**Check Engine MIL Illuminated/Excess Engine Noise – Replace Cracked EGR Transfer Pipe – Service Action S701**MODEL 1998-99 MY  
XJR

VIN 812256-878717

ILLUSTRATION 1

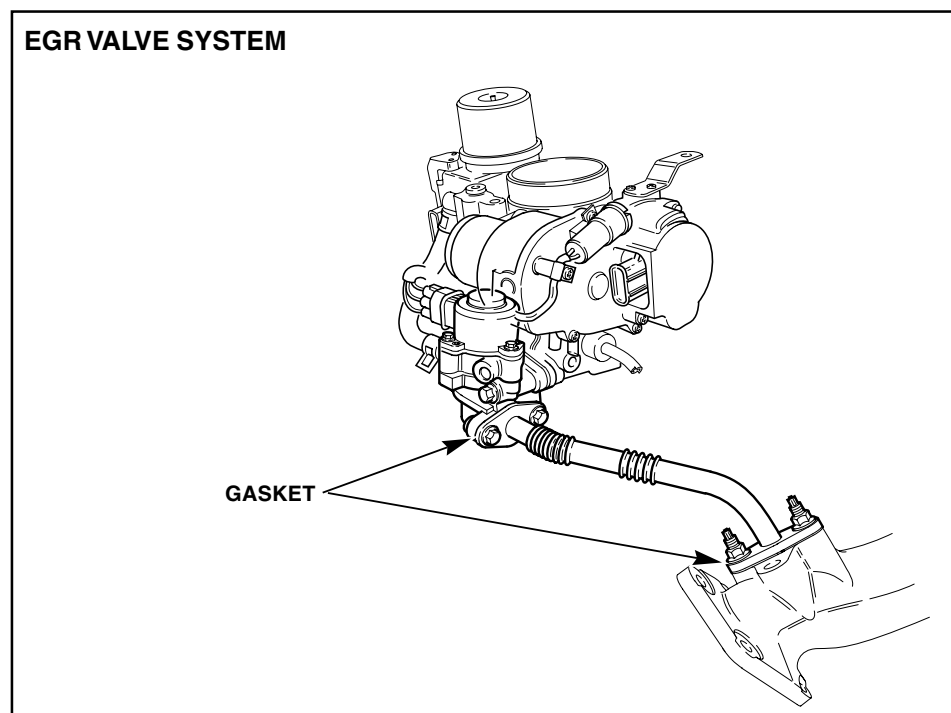
Some 1998-99 MY XJR vehicles within the above VIN range may experience illumination of the check engine light and/or customer complaints of excess engine noise. This condition can be caused by a cracked EGR transfer pipe.

In order to reduce potential customer complaints, the EGR transfer pipe must be replaced on all vehicles within the above VIN range at the next service opportunity or in case of a customer concern.

1. Open the hood and place covers over the fenders.
2. Remove the air intake duct, mass air flow sensor, and air cleaner as an assembly.
3. Loosen and remove the bolts securing the EGR transfer pipe to the EGR valve (Illustration 1).
